Item Name: Fwd Crosstube - High 206L / L1 / L3 / L4

Draw Nbr	Revision Nbr
D206-667-143	Rev C (DEO)
DSI9565	A
DSI9628	A

DART AEROSPACE LTD		Work Order:	132092
Description: Crosstube High Fwd (206L)		Part Number:	D206-667-103
Inspection Dwg: D206-667-143	Rev: C	Page 1 of 1

DRAWING NO. D206-667-143	TITLE CROSSTUBE ASS'Y (206L HIGH FWD)	REV. C	DART AEROSPACE LTD ENGINEERING ORDER		D.E.O. NO. D206-667-143-C-1	SHEET NO. SHEET 1 OF 1	SCALE NTS
DRAWN P	CHECKED ASS	MFG. APPR. PDS	APPROVED MD		DE APPR. H		
DATE 11.07.15	DATE 11.07.20	DATE 11.07.21	DATE 11/07/21		DATE 11.07.21

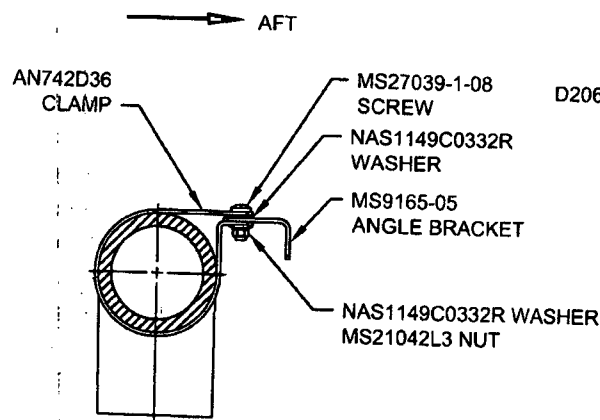
ADD ELECTRICAL GROUNDING STRAP

ADD

- 16) MASK AREA UNDER CLAMP PRIOR TO PAINTING
- 17) SEAL EDGES WHERE AN742D36 CLAMP MEETS WITH THE CROSSTUBE USING SIKAFLEX-241/-291 OR MIL-S-8802 CLASS B2 OR PROSEAL 890 SEALANT
- 18) PERFORM RESISTANCE CHECK TO ENSURE MAX RESISTANCE IS 10 MILLIOHMS
